PLANNING, ZONING, & BUILDING DEPARTMENT
PZ&B Staff Combination Memorandum: Architectural Commission and Town Council

SUBJECT: ARC-24-0029 (ZON-24-0023) 242 PARK AVE

MEETING: SEPTEMBER 25, 2024 ARCOM
OCTOBER 09, 2024 TC

Existing west elevation.

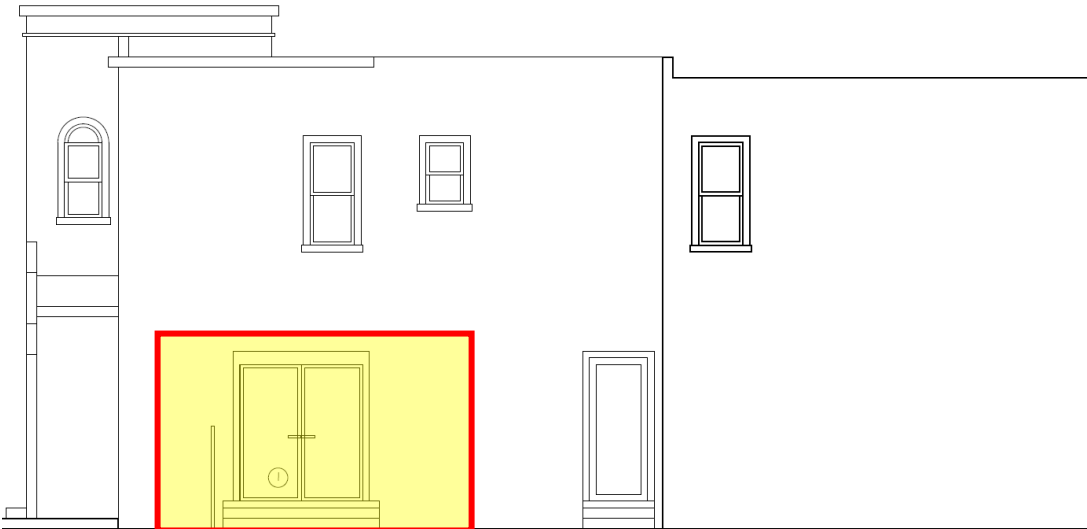
The applicant has resubmitted plans addressing comments of the commission from the August hearing. The arrangement of fenestration on the first floor street facing façade is proposed to remain. The applicant has resubmitted plans which now proposed modification to the west façade of the main massing to provide new glass doors which will open to the proposed new swimming pool. The changes are not readily visible from the Park Avenue right-of-way due to an opaque

fence fronting Park Avenue with tall, dense plantings behind.

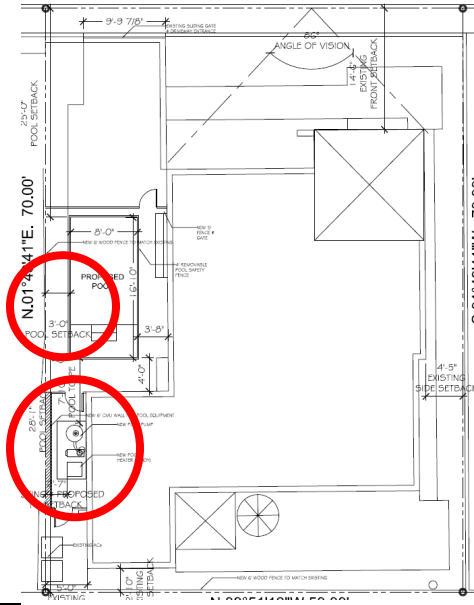
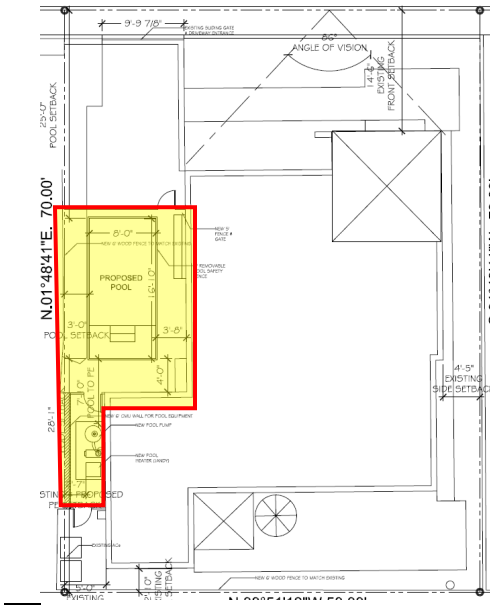
In addition to the fenestration alterations, the applicant also proposes the installation of a small plunge pool in front of the house. The placement of the pool is 25'-0" from the front property line and out of the required front yard setback. The swimming pool is proposed to replace the end segment of the existing driveway and a new 5'-0" high fence and gate will separate the pool area from the drive. The existing drive currently can park two (2) stacked vehicles. For a lot of this size, only one 9' x 18' parking space is required on site and the applicant proposes to maintain one parking space. The applicant affirms that the scope of work will not result in the loss of any existing open space, and that the swimming pool and any related hardscape improvements will occur within the current footprint of the existing driveway surface. As previously mentioned, the existing site features many nonconforming aspects, and leaves few options for this type of improvement. As a result, 3 variance requests must be granted for the scope of work as it relates to pool setback and equipment setback. The variance previously requested to forgo masonry wall screening for the pool heater has been eliminated in this resubmission.

Code Section	Permitted/Required	Proposed	Variance
<u>VARIANCE 1:</u> Sec. 134-1757	10'-0" side-yard for swimming pools.	3'-0" swimming pool side yard setback	7'
<u>VARIANCE 2:</u> Sec. 134-1728(c)(1)	5'-0" side-yard setback for swimming pool pumps and filters.	2.58' side yard setback for swimming pool pump and filter	2.42'
<u>VARIANCE 3:</u> Sec. 134-1728(c)(2):	Min 10' side-yard for swimming pool heaters.	2.58' side yard for swimming pool heaters	7.42'
